Planning Commission Meeting Agenda
Hartland Township Hall
Thursday, August 11, 2022
7:00 PM

Subject: Site Plan #22-009 Charyl Stockwell Academy-Building Addition

RE: Charyl Stockwell Academy – Concept Plan Review Response
SDA Review No. HL22-114
IA Project No. 20220121

3D ISOMETRIC - SOUTH WEST

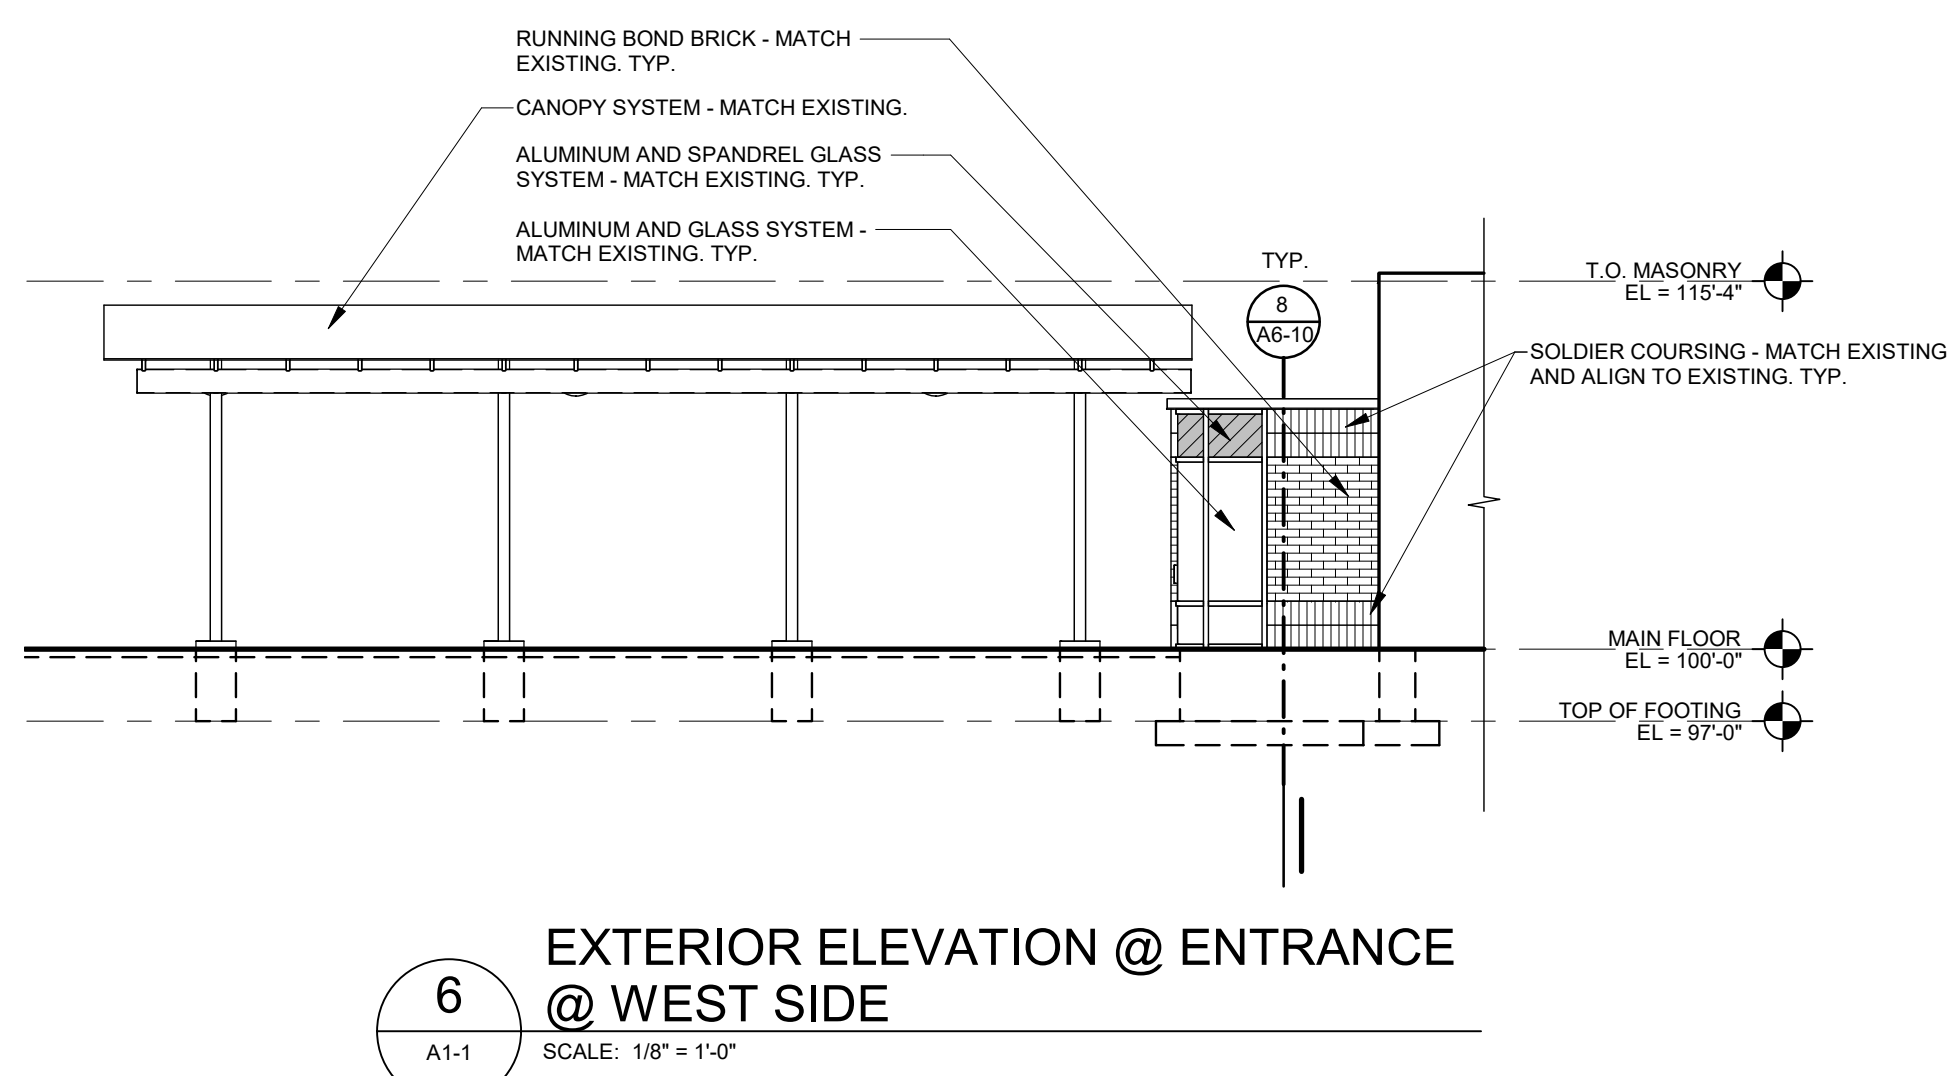
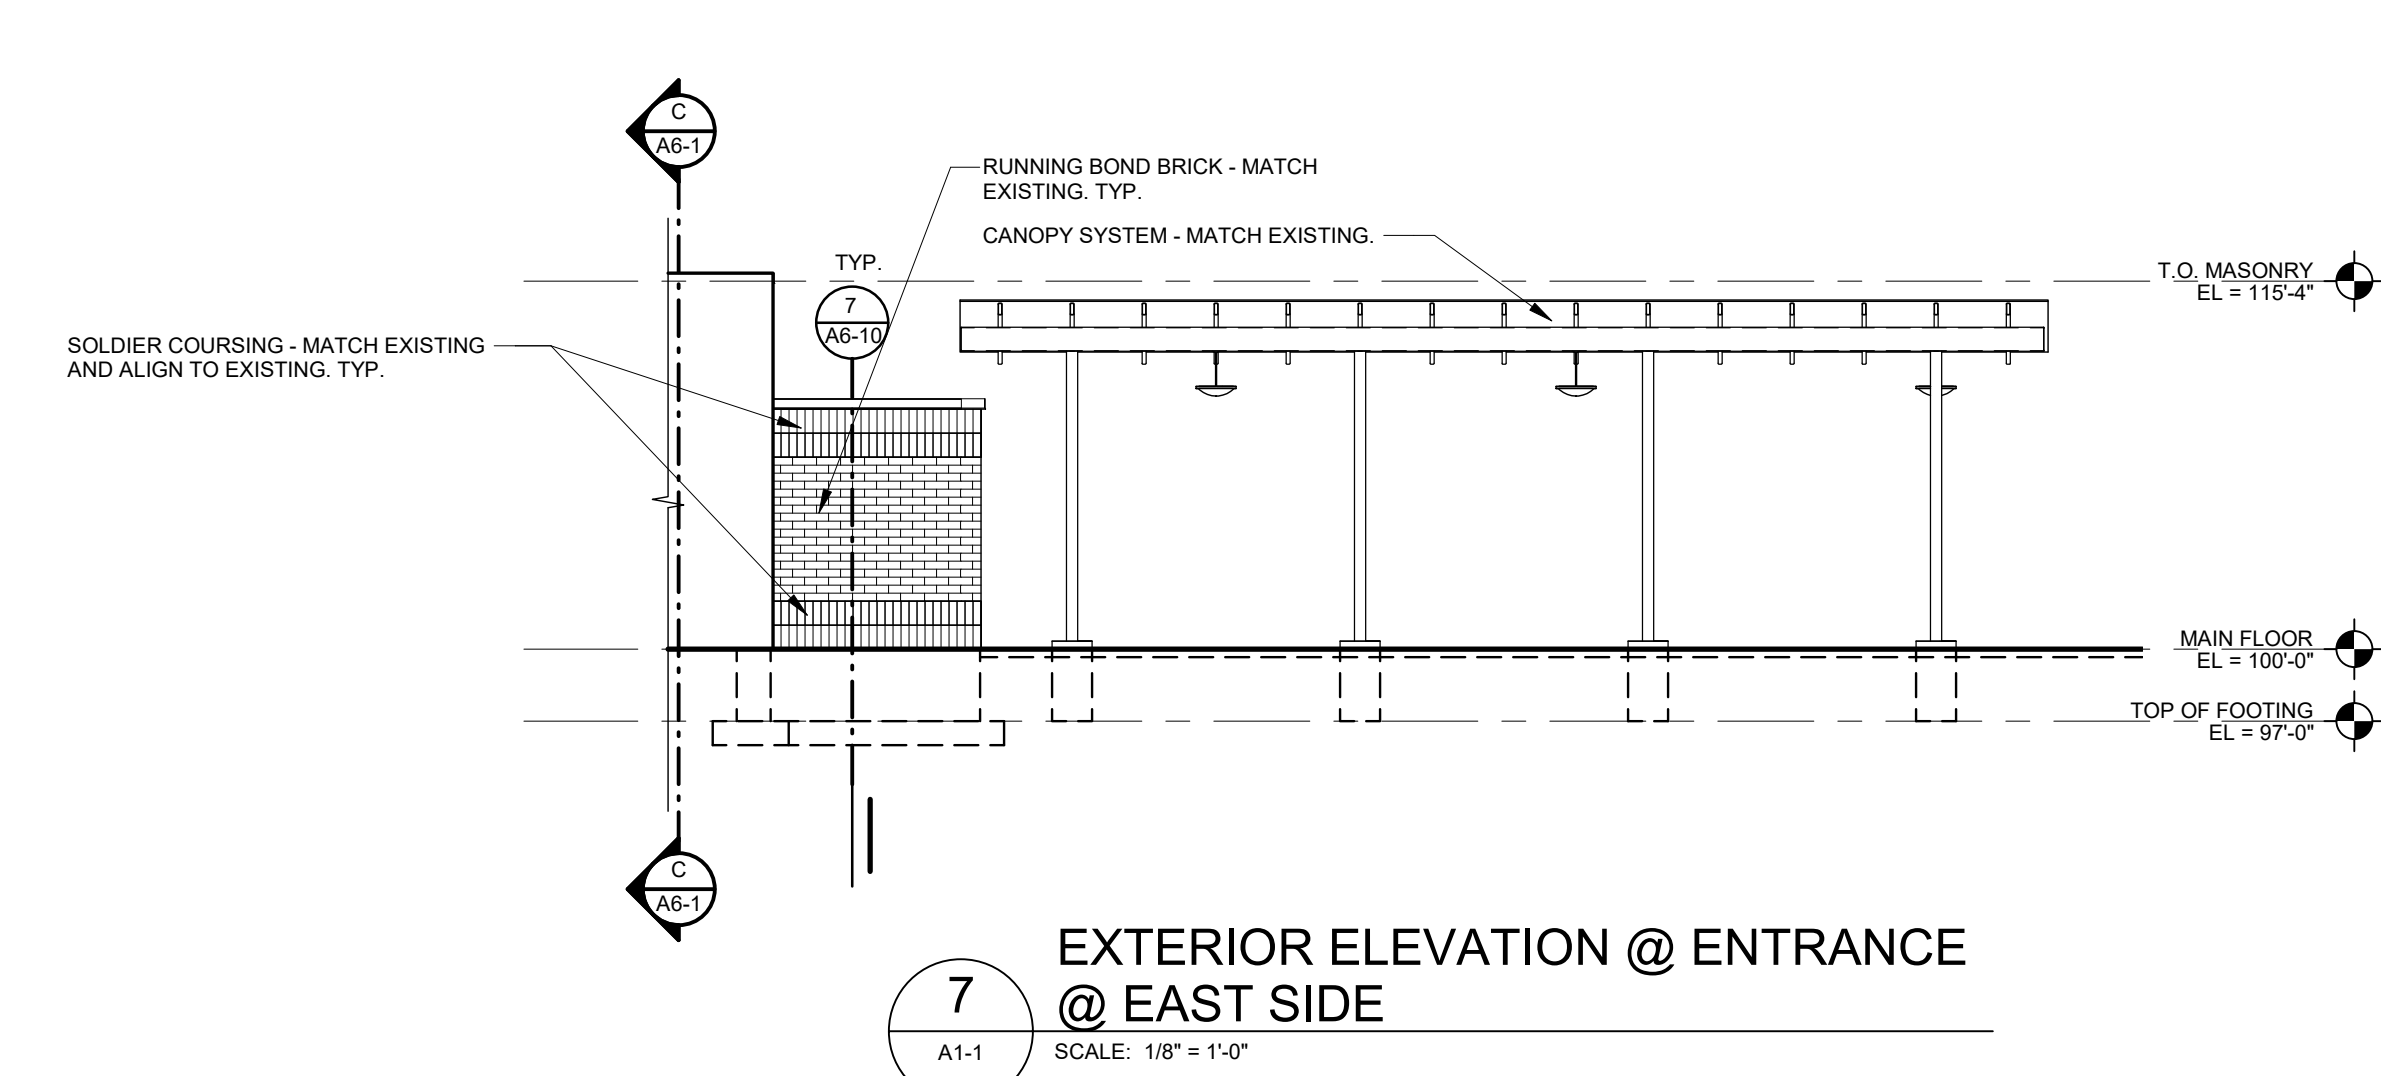
8. Please label the skylight on Sheet A4-1 and Sheet A5-1.

Response: See attached sheets with added labels.

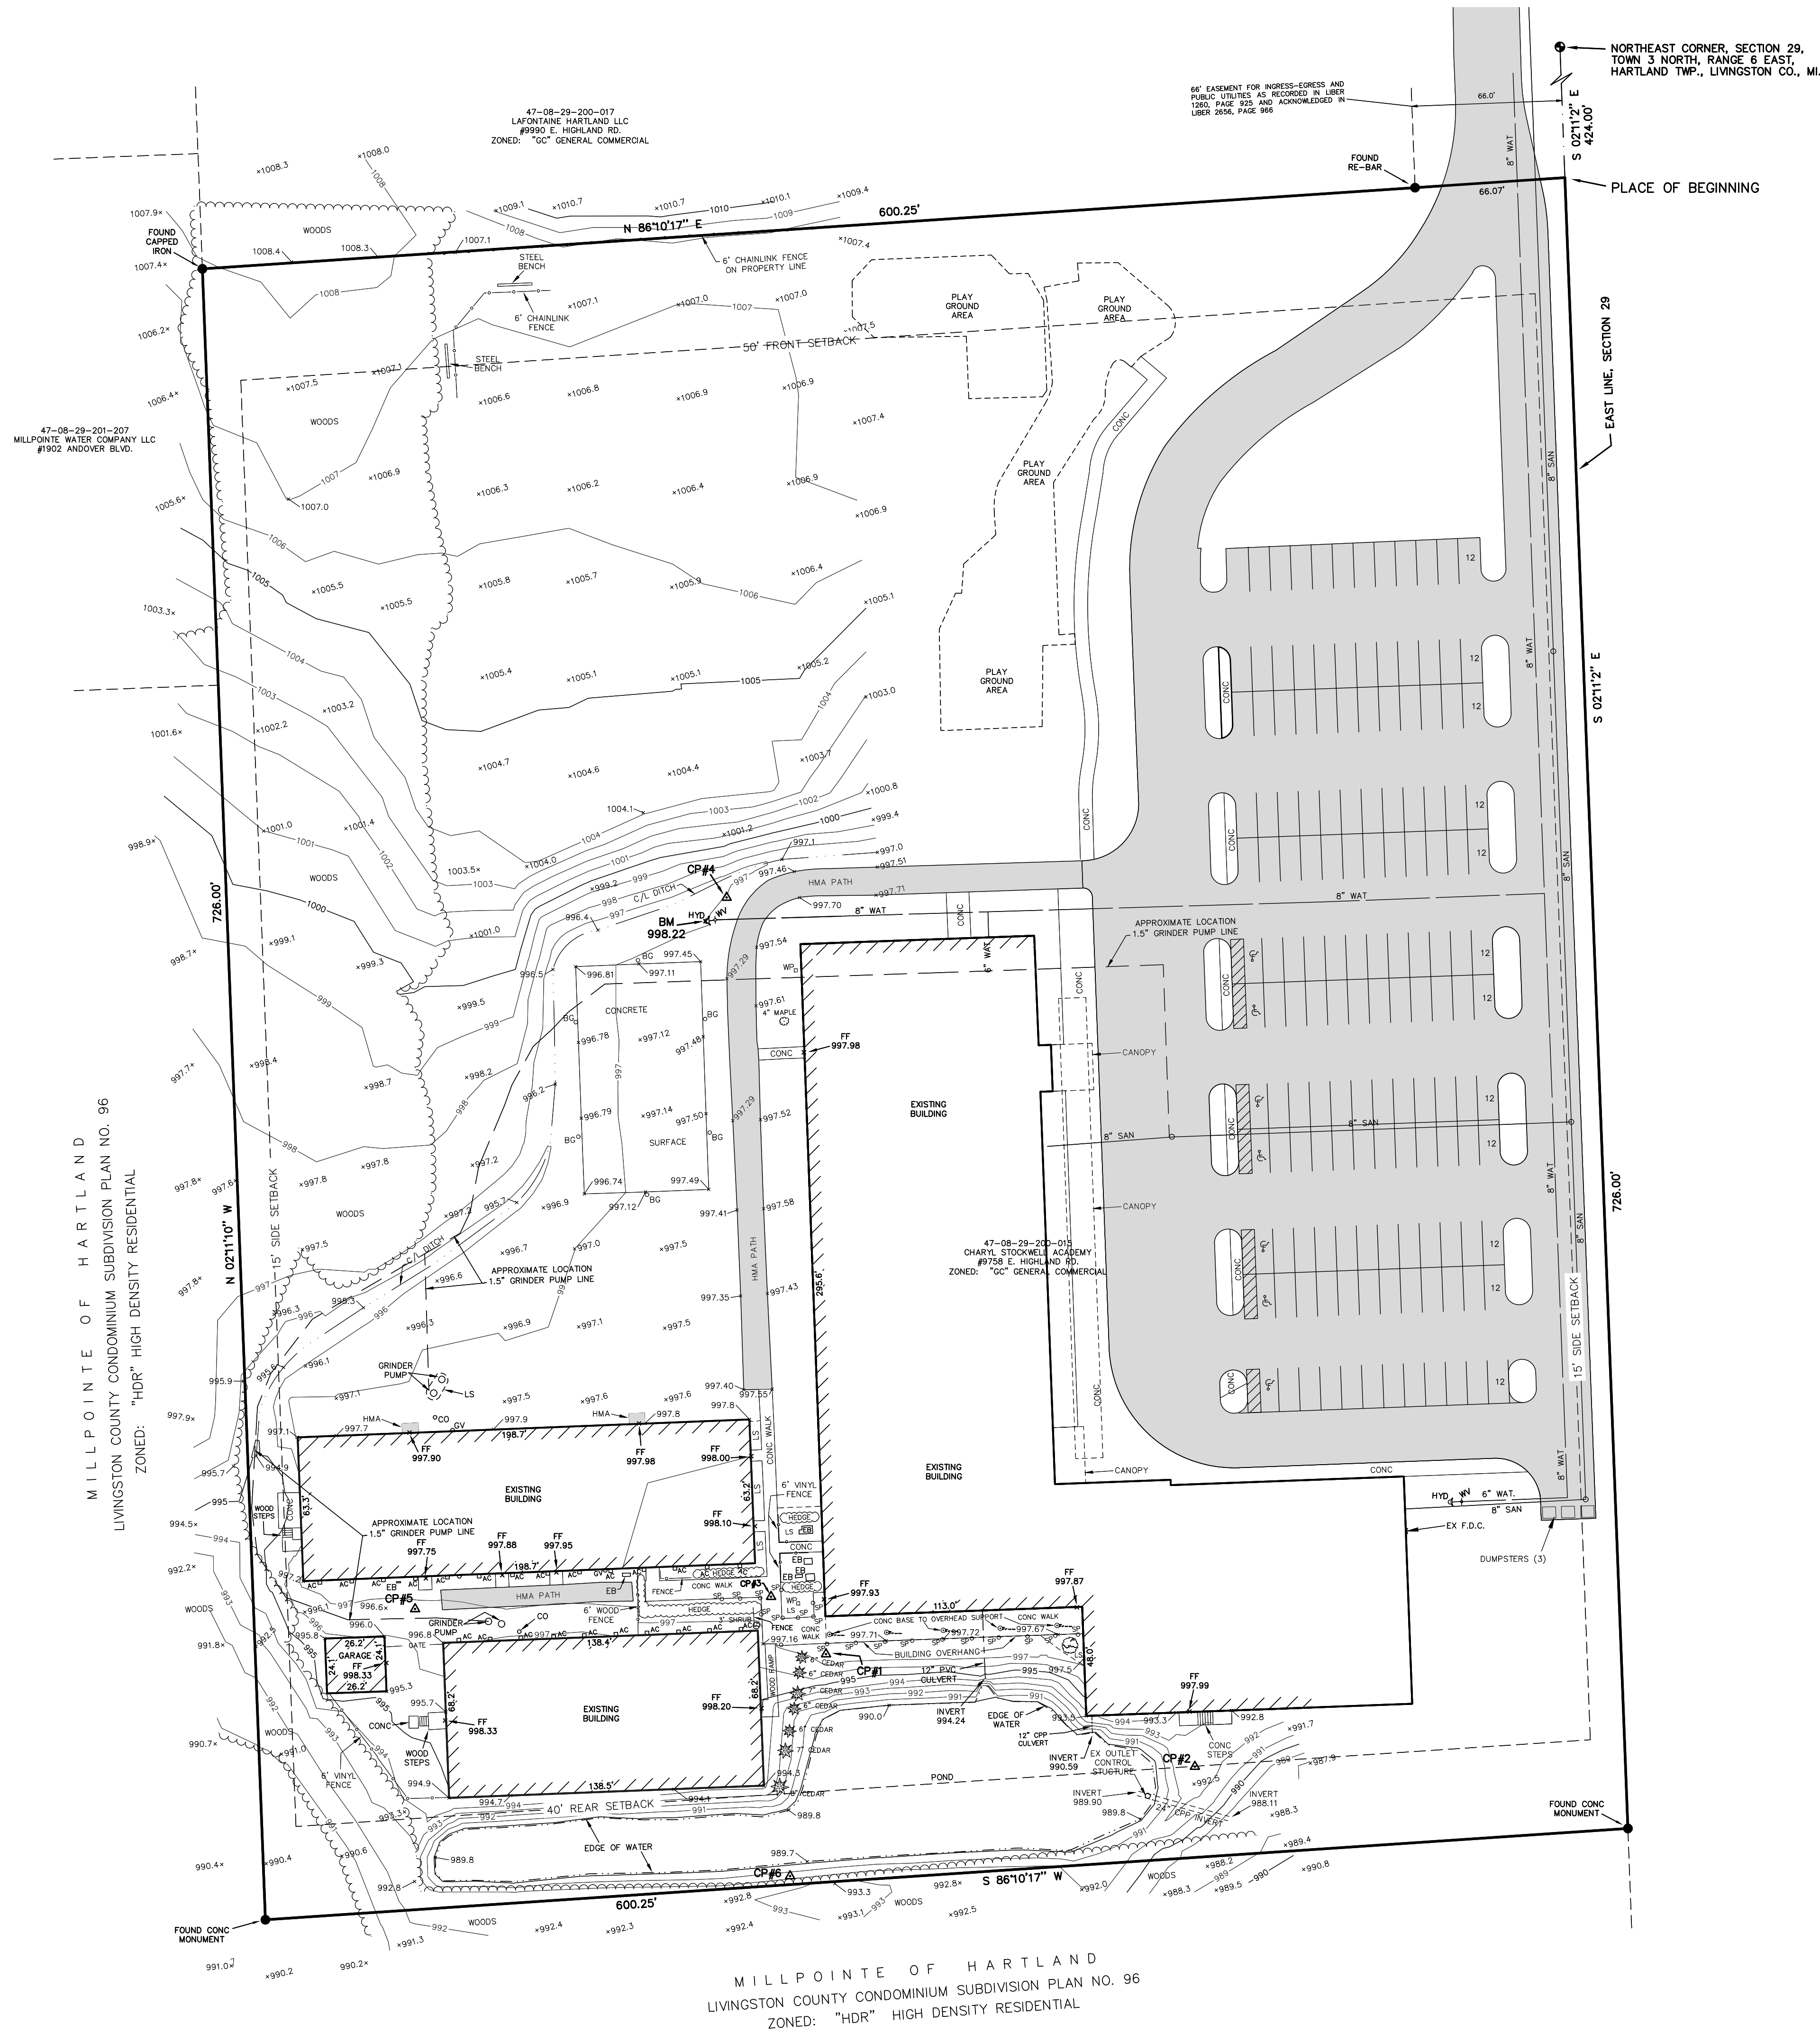
7. Sheet C-1.0: If the existing trees on the west side of the property are to be used for screening purposes, please provide a general description of the tree types and size (height mostly). Also fence protection of the wooded area should be shown on the plans if the trees are to be preserved. Screening is required along adjoining boundaries of a non-residential use and an abutting single family residential zoned property (Millpointe to the east).

Response: See sheet C1.0 attached. The existing tree line along the west edge of the property is moderately wooded with a mixture of deciduous and coniferous trees. 50% of the trees are fir and spruce ranging in height between 25' and 30'. The other 50% of trees are fir, spruce, birch, cherry, oak, and cottonwood, ranging in height between 35' and 75'. It is the desire of the school to use the existing natural buffers along the residential properties adjacent to the property lines.
